United States Patent and Trademark Office

APPLICATION NO.	FILING DATE	FIRST NAMED INVENTOR	ATTORNEY DOCKET NO.	CONFIRMATION N
10/725,683	12/02/2003	James L. Chappuis	050313-1130	3417
24504	7590 10/03/2006		EXAMINER	
	, KAYDEN, HORSTEN	RAMANA, ANURADHA		
100 GALLERIA PARKWAY, NW STE 1750 ATLANTA, GA 30339-5948			ART UNIT	PAPER NUMBER
			3733

DETAILED ACTION

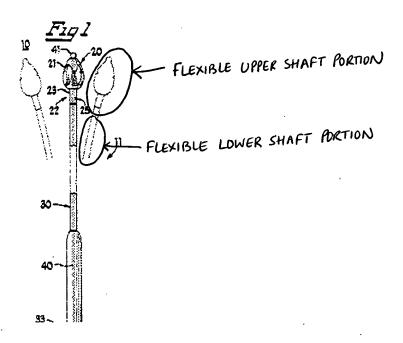
Claims 1-2 and 6 are rejected under 35 U.S.C. 102(b) as being anticipated by Steiner et al. (US 5,499,984).

Steiner et al. disclose a flexible tap apparatus member (20, 30) including a flexible upper shaft portion including ridges 21 and a flexible lower shaft portion that is coupled to an adaptor or "handle" 33 (Figs. 1 and 10, col. 3, lines 31-67, col. 4, lines 1-50 and col. 5, lines 41-47). See marked up Figure 1 from Steiner et al. on the following page.

Applicant's arguments with respect to the rejections of claims 1-6 as being anticipated by Steiner et al. are not persuasive because Steiner et al. clearly disclose a flexible tap apparatus member. It is noted that the limitation "a flexible upper shaft portion" only requires an upper portion of the shaft to be flexible.

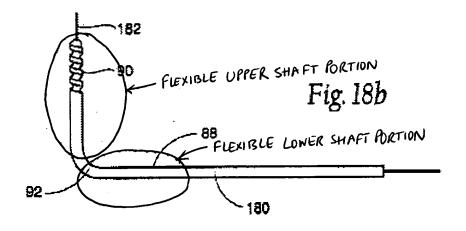
Claims 1-6 are rejected under 35 U.S.C. 102(e) as being anticipated by Boucher et al. (US 6,716,216).

Boucher et al. disclose a flexible tap apparatus member including an upper shaft portion having ridges 90, a lower shaft portion having a substantially smooth surface, an axial passage extending along the flexible shaft, a guide pin 76 and a handle 80 configured to receive the lower shaft portion (Figs. 16D and 18A-C, col. 13, lines 62-67 and col. 14, lines 1-23). See marked up Fig. 18b below.

Applicant's arguments with respect to the rejections of claims 1-6 as being anticipated by Boucher et al. are not persuasive because, Boucher et al. clearly disclose a flexible tap apparatus member having a flexible upper shaft portion (Figs. 18a-18c). It is noted again that the limitation "a flexible upper shaft portion" only requires an upper portion of the shaft to be flexible.
